Access Compliance Report

## Public Rights-of-Way
(Pedestrian Signals)

Intersection ID: N/A	Main Street:		Cross Street: N/A	Location: N/A
ADA ID: 9F99E9B36F2A	Signal Type: One Push Button-Non APS	Overall Compliance: No	Severity Score: BTN 1: N/A	BTN 2: N/A No BTN: N/A

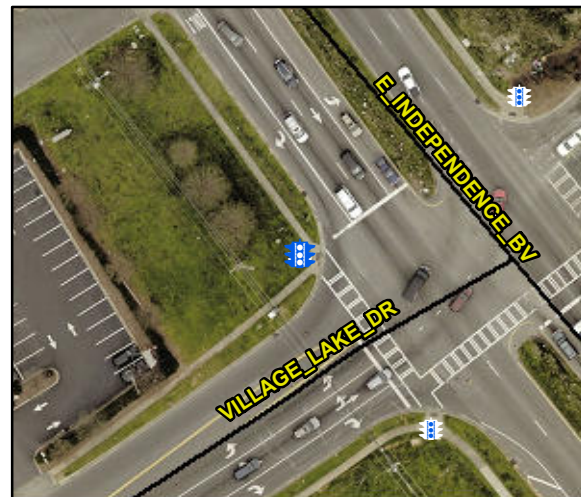
PROW/ADA: R404.2, R404.3, R406.2

Compliance	Description	Data	Compliance	Description	Data
	Button Count	Button1	N/A	Distant to Additional Button (in)	N/A
	Additional Button Present?	No		Additional Button ID	N/A
N/A	Signal Buttons Required?	N/A	N/A	Additional Ped Posts Required	N/A
	How Many Ped Street Xings?	1		Located In An Island/Median?	No
N/A	B 1 Sign Present?	Yes	N/A	B 2 Sign Present?	N/A
Yes	B 1 Sign Purpose?	Yes	N/A	B 2 Sign Purpose?	N/A
Yes	B 1 Sign Lettering & Contrast?	Yes	N/A	B 2 Sign Lettering & Contrast?	N/A
Yes	B 1 Parallel To XWalk?	Yes	N/A	B 2 Parallel To XWalk?	N/A
Yes	B 1 PAR to Button?	Yes	N/A	B 2 PAR to Button?	N/A
Yes	B 1 PAR to XWalk?	Yes	N/A	B 2 PAR to XWalk?	N/A
Yes	B 1 Clear Floor Space?	Yes	N/A	B 2 Clear Floor Space?	N/A
N/A	B 1 FWD Approach?	Yes	N/A	B 2 FWD Approach?	N/A
N/A	B 1 FWD Approach Constrained?	No	N/A	B 2 FWD Approach Constrained?	N/A
No	B 1 FWD Approach Reach (in)	10.0	N/A	B 2 FWD Approach Reach (in)	N/A

N/A	B 1 FWD Approach Width (in)	N/A	N/A	B 2 FWD Approach Width (in)	N/A
N/A	B 1 FWD Approach Obstruction?	Yes	N/A	B 2 FWD Approach Obstruction?	N/A
N/A	B 1 FWD Approach Obstruction Dist (in)	6.0	N/A	B 2 FWD Approach ObstructionDist (in)	N/A
N/A	B 1 PARA Approach?	Yes	N/A	B 2 PARA Approach?	N/A
N/A	B 1 PARA Approach Constrained?	No	N/A	B 2 PARA Approach Constrained?	N/A
Yes	B 1 PARA Approach Reach (in)	7.0	N/A	B 2 PARA Approach Reach (in)	N/A
N/A	B 1 PARA Approach Width (in)	N/A	N/A	B 2 PARA Approach Width (in)	N/A
N/A	B 1 PARA Approach Obstruction?	Yes	N/A	B 2 PARA Approach Obstruction?	N/A
N/A	B 1 PARA Approach Obstruction Dist (in)	6.0	N/A	B 2 PARA Approach ObstructionDist (in)	N/A
No	B 1 Clear Floor Space Slope (%)	14.0	N/A	B 2 Clear Floor Space Slope (%)	N/A
No	B 1 Clear Floor Space XSlope (%)	14.5	N/A	B 2 Clear Floor Space XSlope (%)	N/A
N/A	B 1 PAR Slope (%)	1.6	N/A	B 2 PAR Slope (%)	N/A
Yes	B 1 Height (in)	38.0	N/A	B 2 Height (in)	N/A

Possible Solutions: Provide Push Button Extension. Remove and Replace Clear Space.
